Memo

Development Assessment

Date: 11 April 2025

Subject: DA2024/1295 - 7 Crane Lodge Place, Palm Beach

Diagram 1 – Submitted by the owner of 6 Crane Lodge Place

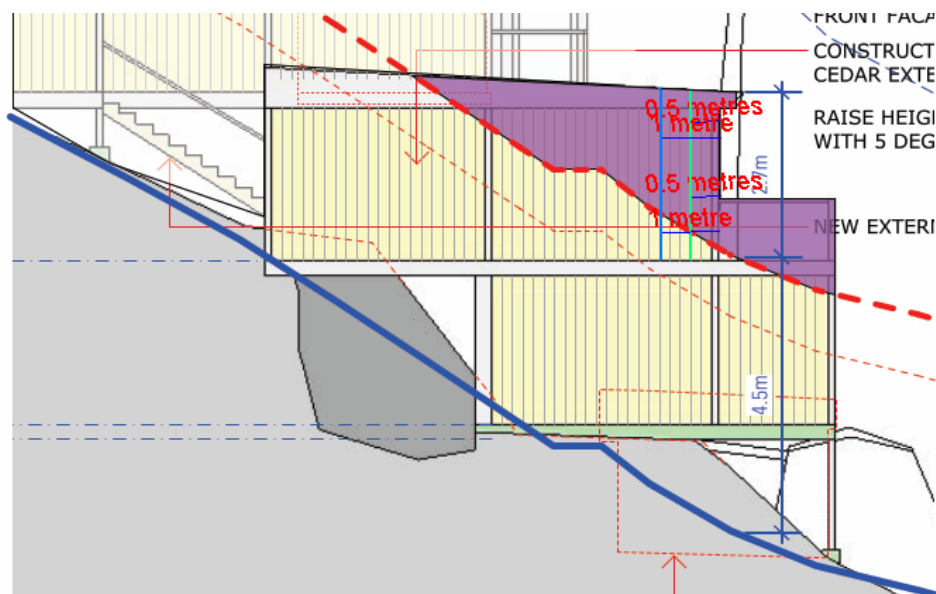
A slide presentation was submitted by the owner of 6 Crane Lodge Place, Palm Beach and displayed to members of the DDP. The slides aimed to demonstrate potential view loss from the master bedroom of 6 Crane Lodge Place and raised concerns about a breach of the building envelope along the western elevation.

It is noted that the diagrams submitted by the owner differ from those included in Council's assessment report. No written statement or evidence was provided to support the methodology used to calculate the building envelope in the submission.

- Owner's consent has now been received from the owners of 8 Crane Lodge Place. Accordingly, *Condition 13 (ii)* may be deleted.
- The building envelope recalculation has been completed by Council's Planner, based on surveyed data. It is considered that the differences between the diagrams submitted by the owner and those used in Council's assessment are not significantly dissimilar.

Diagram 2 – Recalculated building envelope by Council's Planner

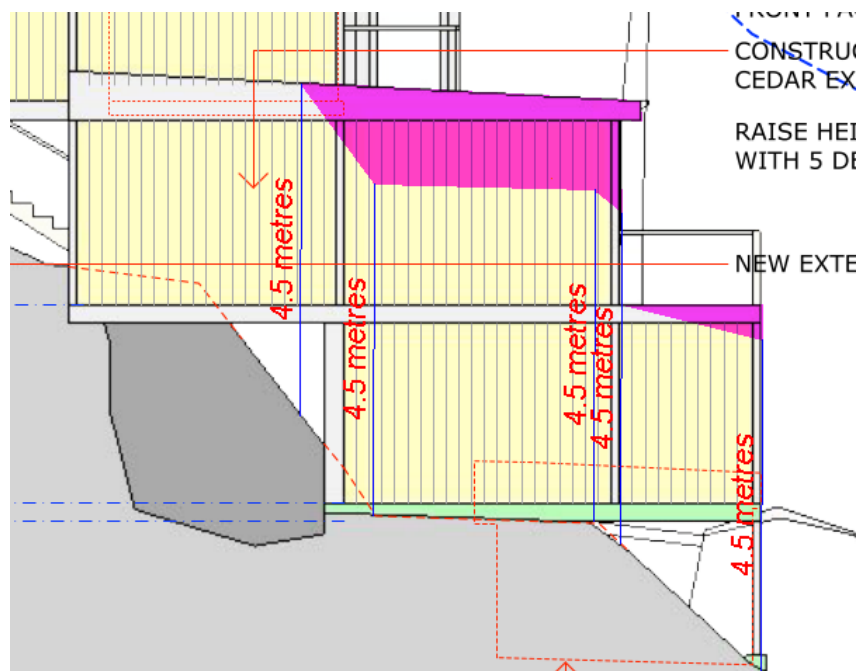
Council's Planner has recalculated the building envelope on the western elevation, cross-referencing the survey information lodged with the application. The revised calculation includes the roof form; however, the proposed balustrade for the balcony is excluded from the envelope diagram/calculation, as the following condition removes this element:

(i) *"The proposed deck off the painting studio must be removed. A Juliette balcony may be installed with a balustrade that complies with the National Construction Code (NCC). The deck area is to be replaced with either a flat roof or a roof with a slope not exceeding 1%, sloping down from the painting studio to the southern end of the building."*

- The proposed outbuilding does not exceed two (2) storeys in height.
- The envelope encroachment does not exceed one (1) storey at any point, considering the removal of the balcony by condition.

- The balustrade associated with the now-deleted balcony is not required to be included in building envelope calculations.
- Clause D12.8 of P21DCP allows variation to the building envelope control on a merit basis where the slope exceeds 16.7 degrees (30%). In this case, the subject site has a slope of approximately 26.1 degrees (49%), and the non-compliance is attributed to the steep topography. The proposed development is considered acceptable under the relevant planning controls.
